GERALD R. FORD INTERNATIONAL AIRPORT

**TAXIWAY F & G RECONSTRUCTION (NORTH OF TAXIWAY V, 1,950' X 35');
TAXIWAY F & G AIRFIELD LIGHTING REPLACE**

PROJECT NUMBER C-435

ADDENDUM #1

1 PROPOSED ELEVATED TAXIWAY EDGE LIGHT IN TURF DETAIL
 SCALE: N.T.S.

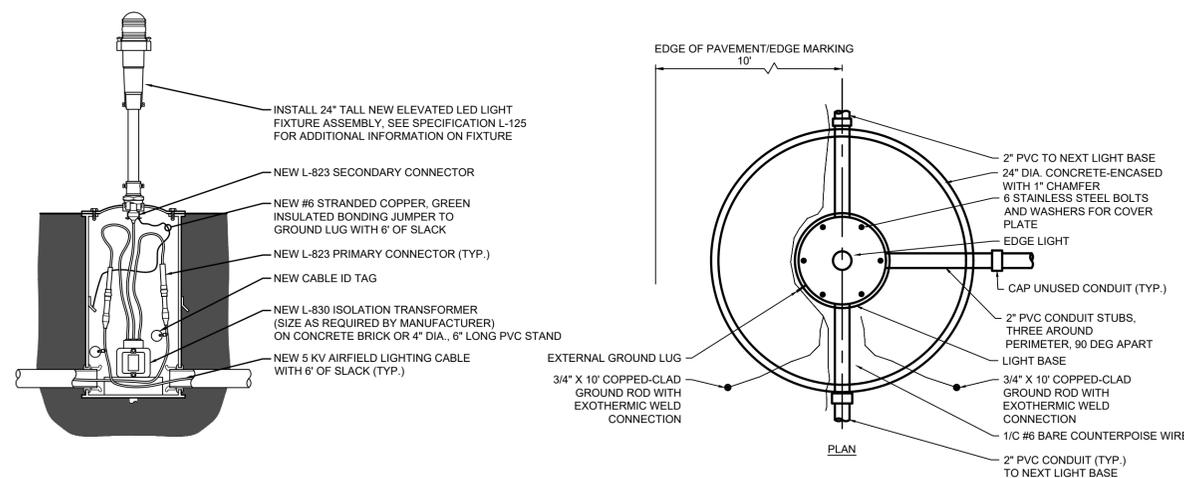
Q: Is there a detail for the new edge lights? The detail on sheet E-302 does not seem applicable to this project.

A: That is the incorrect detail - we will revise and update the sheet. It will be a single base can. See updated sheet E302 attached.

16. **REPLACE** Drawing E302 with **REVISED** E302 sheet provided with this addendum as a separate document. Revisions are denoted with a cloud referenced to Revision 1 dated MARCH 6, 2026.

1 1-WAY, 2-INCH PVC CONDUIT IN TURF
NTS

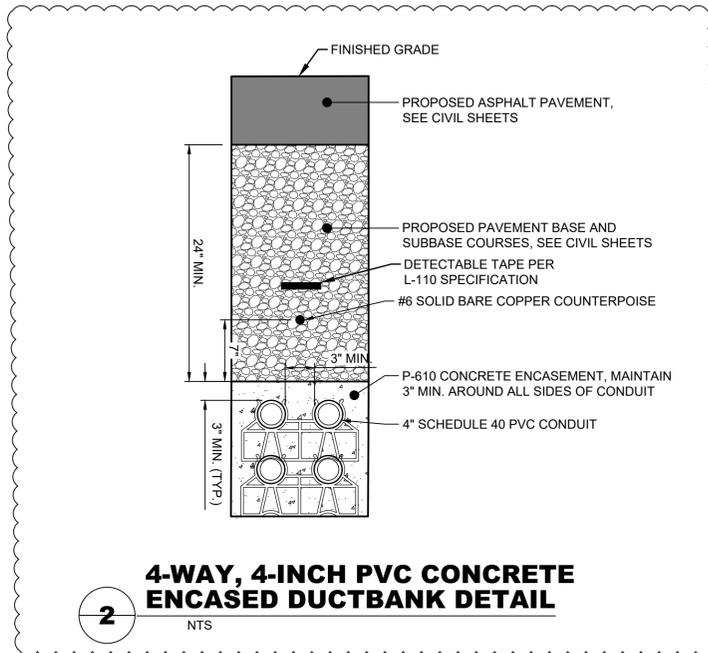
Q: Is there a detail for the 2" Sch 40 conduit and 4-4" duct bank? The details on sheet E-305 does not seem applicable to this project.

A: Detail 1 will be updated to show 2" PVC conduit in trench - not concrete encased. Detail 2 will be updated to show 4-way, 4-inch concrete encased duct bank. The dimensions are similar. See updated sheet E305 attached.

17. **REPLACE** Drawing E305 with **REVISED** E305 sheet provided with this addendum as a separate document. Revisions are denoted with a cloud referenced to Revision 1 dated MARCH 6, 2026.
